## ENVIRONMENTAL PROTECTION AGENCY

### Air Plan Partial Approval and Partial Disapproval; Utah; Regional Haze State Implementation Plan for the Second Implementation Period; Air Plan Disapproval; Utah; Interstate Transport of Air Pollution for the 2015 8-Hour Ozone National Ambient Air Quality Standards

**ACTION:** Proposed rule.

**Figure 1. Sources Required to Perform Four-Factor Analysis and CCI Paradox Lisbon Natural Gas Plant**

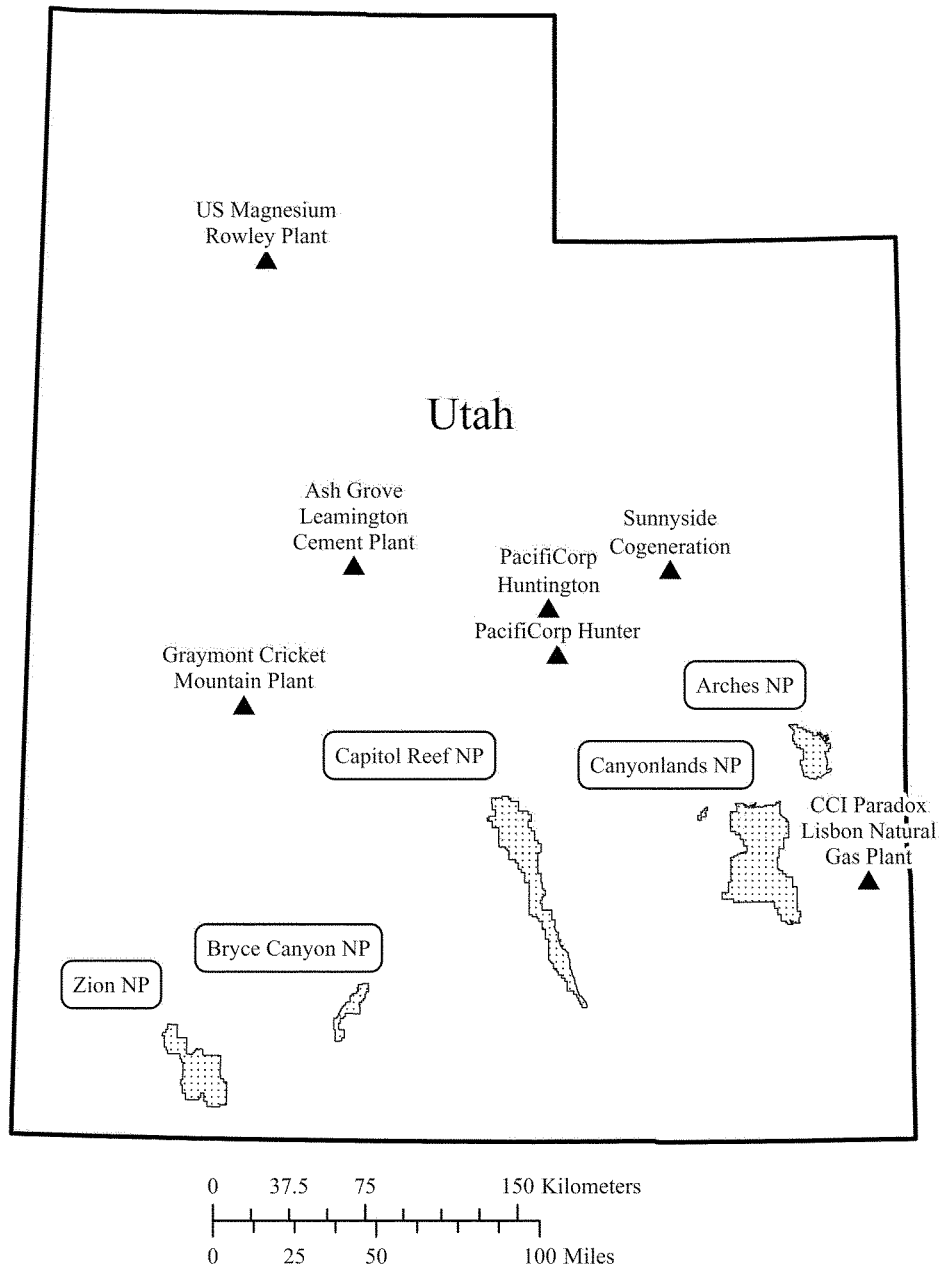
Figure 1 below shows the six sources Utah selected for four-factor analysis and their proximity to the State's Class I areas. We have also included CCI Paradox Lisbon Natural Gas Plant in figure 1 because, as detailed in section IV.C.2.b. of this document, we find that Utah unreasonably excluded this source from four-factor analysis.

**Figure 2. Annual Actual NO<sub>x</sub> Emissions at Hunter Compared to Utah’s Plantwide Mass-Based Emission Limits and 2028OTBa2 Projected Emissions<sup>108</sup>**

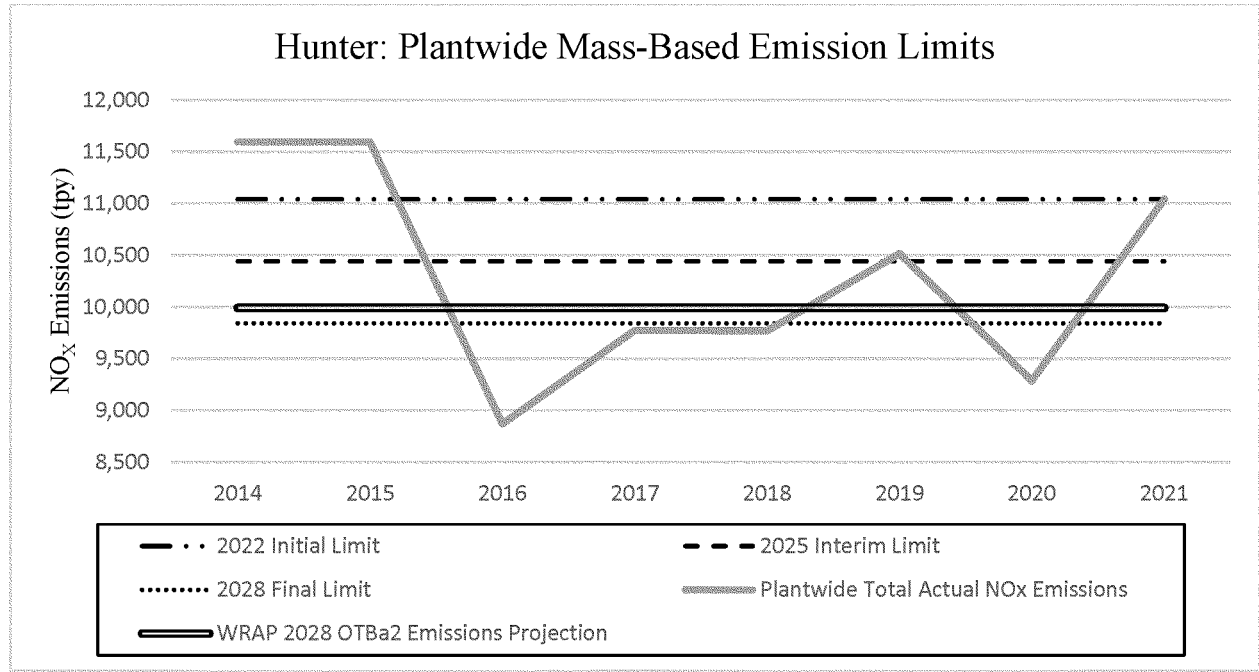
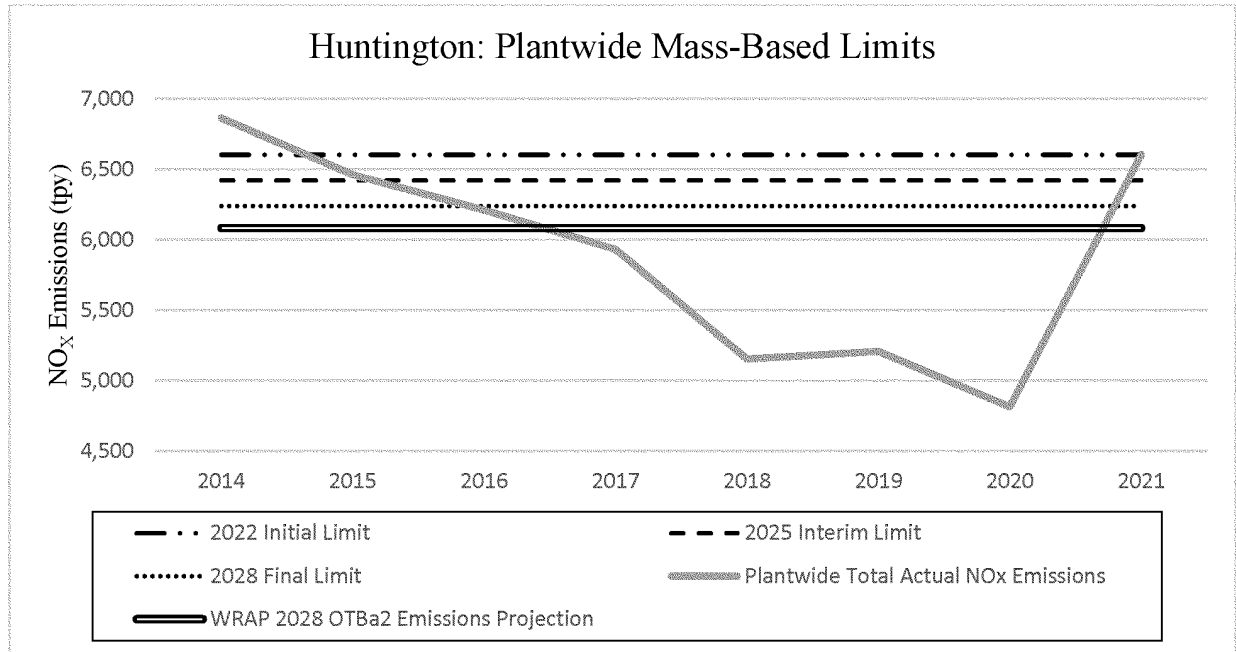
Utah’s determination to impose plantwide annual mass-based emission limits will not secure any reduction in NO<sub>x</sub> emissions from Hunter and Huntington.<sup>105</sup> Tables 12–13 and figures 2–3 of this document compare annual emissions levels allowed under the plantwide annual mass-based emission limits to Hunter and Huntington’s recent actual (2014–2021) emissions and to WRAP’s projections of the plants’

in a net *increase* in NO<sub>x</sub> emissions of 8 tpy from Hunter and Huntington combined, compared to WRAP’s projected 2028 emissions.<sup>106</sup> Table 13 and figures 2–3 show that both power plants’ recent actual (2014–2021) NO<sub>x</sub> emissions were, in many years, lower than the initial, interim, and/or final
